Addendum #3

Bid Opportunity: 23-7367-RFT - King Edward Public School Accessibility Upgrade including Elevator and Washrooms

DRAWING: HOISTWAY PLAN VIEW

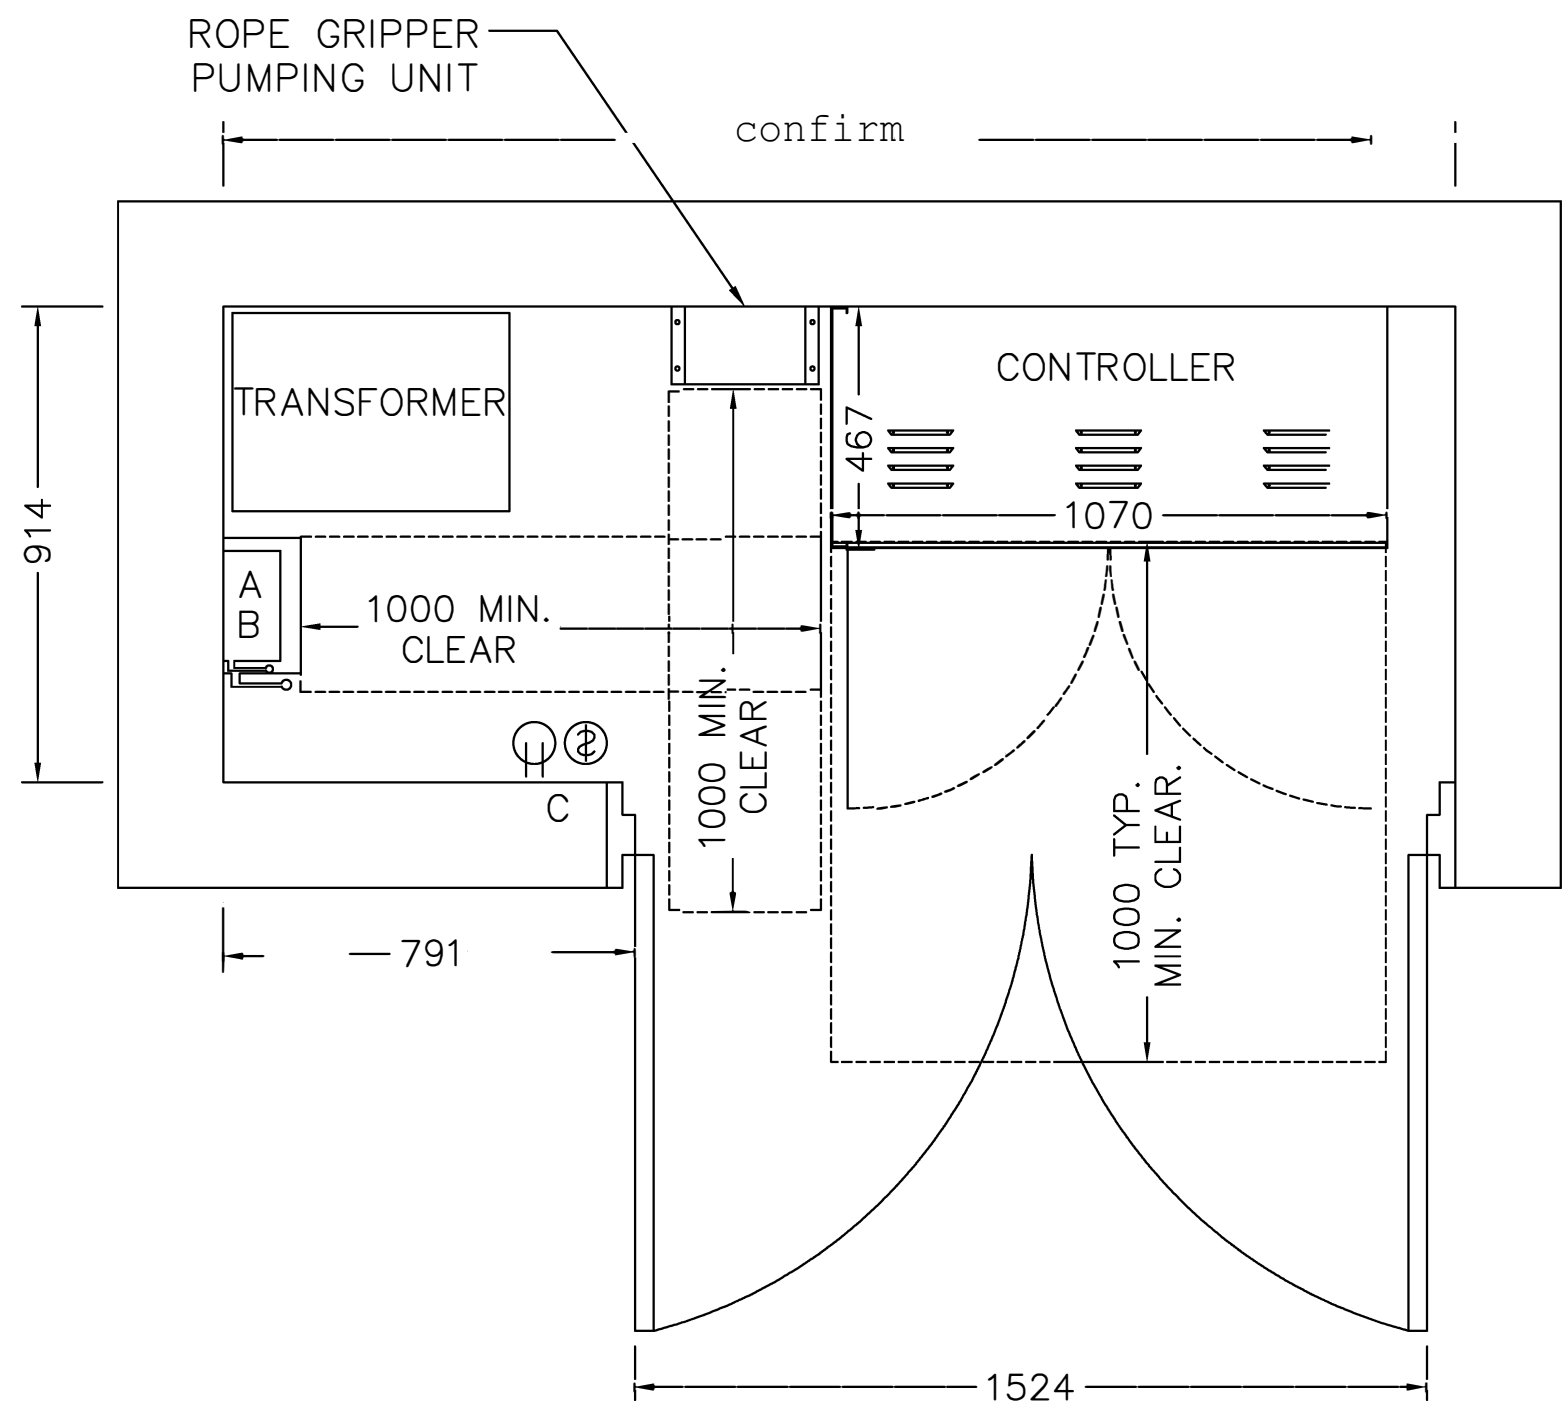
The spec asks for a MRL traction elevator, however, the title of the elevator section is Holeless hydraulic elevator. The drawings indicate that there is a machine room.

Please clarify what is required and update spec accordingly.

Remove Holess Hydraulic Elevator Section from the Specifications and Add to the Specifications Section 14200 MRL – Machine Room-Less Elevator Deep Pit attached with this Addendum.

The elevator has a control room that has been designed as per the model indicated on the specifications. Is not a full machine room but requires certain equipment to be located there. Refer to Elevator shop drawings attached for reference and the Electrical and Mechanical drawings for coordination.
